Dear editor and referees,

The following is a point-by-point response to the specific comments from referee 1:

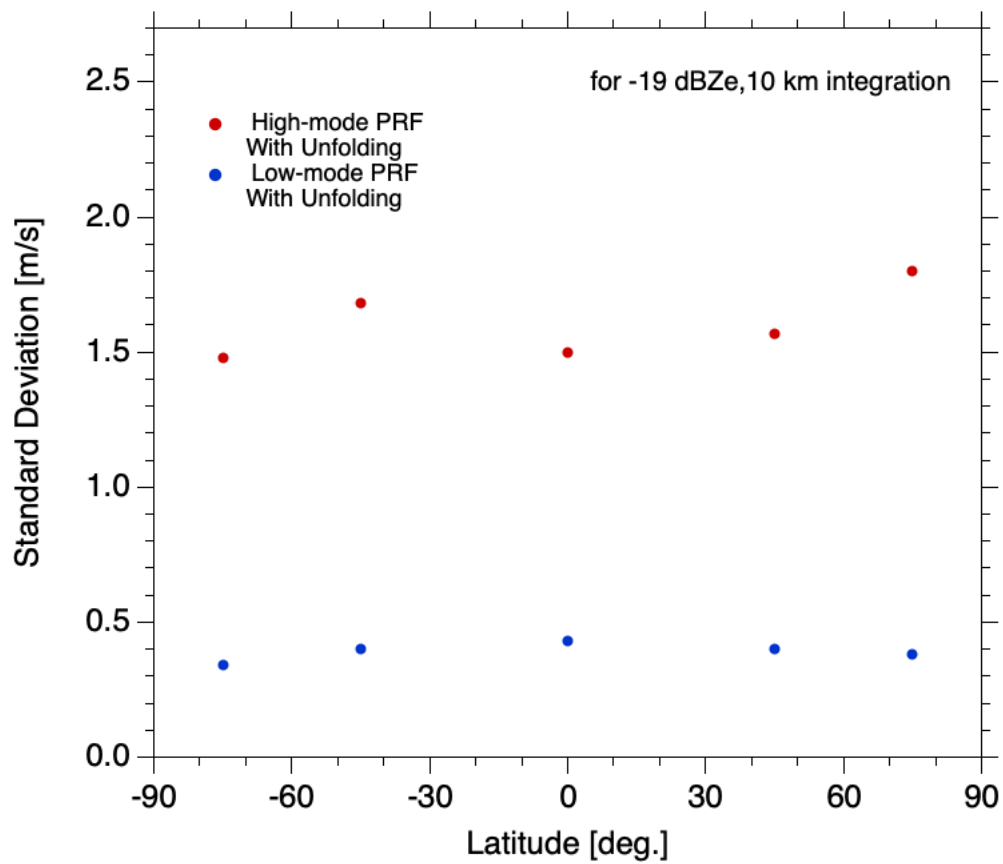
Line 201: "there would be no relationship between the latitudinal variation of SDdiff with unfolding correction and the frequency of precipitation echoes":

That is true only if only high SNR data are considered. The SD_diff depends on the SNR, thus the regions where weak radar echoes are observed often are characterized by higher SD_diff.

The latitudinal variation of SDdiff with unfolding correction for -19dBZe with relatively low SNR is shown below. As in fig. 6, there is no significant variation in latitude.
